NEBRASKA ARMY NATIONAL GUARD 1776 RC DATA CABLING PROJECT

PROJECT NO. 31030134

ADDENDUM NO. 1

1776 RC DATA CABLING
REPLACEMENT
ENLARGED IT CLOSET 167B

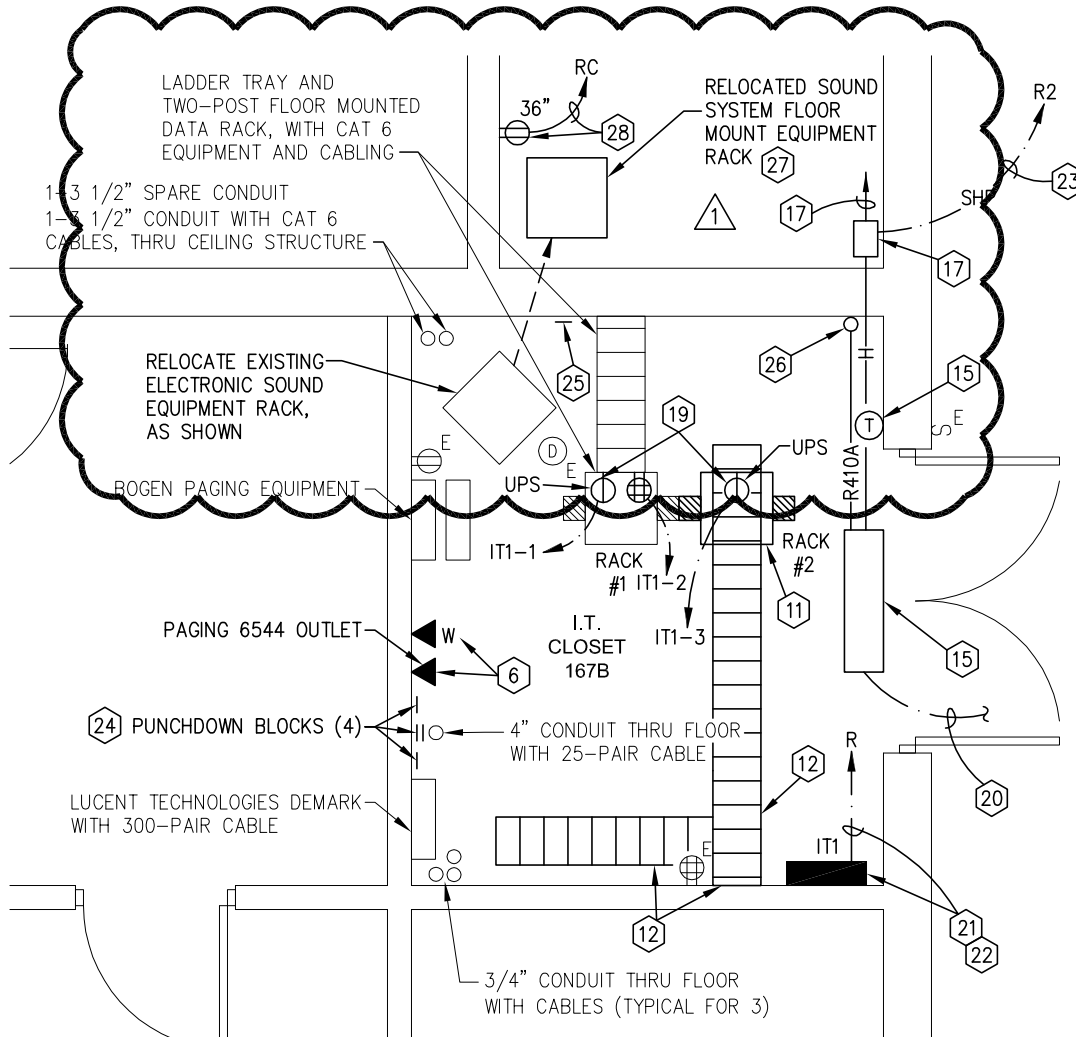
- B. Detail E11, Enlarged IT Closet 167B Plan:
 - 1. Relocate sound system floor mounted equipment rack from northwest corner of room, to Janitor 168, as shown on attached drawing E1.

27. INSTALL 60" HIGH RELOCATED EQUIPMENT RACK BELOW STORAGE SHELVING. EXTEND EXISTING SPEAKER CABLES (7) TO NEW LOCATION, CORE DRILL WALL AND PROVIDE CONDUIT SLEEVE AS REQUIRED FOR CABLES. FIRE SEAL ENDS OF CONDUIT, AFTER INSTALLATION OF CABLES.
28. NEW SOUND SYSTEM DUPLEX OUTLET AND 20A, 120V CIRCUIT TO DESIGNATED PANEL. CONNECT TO SPARE BREAKER.
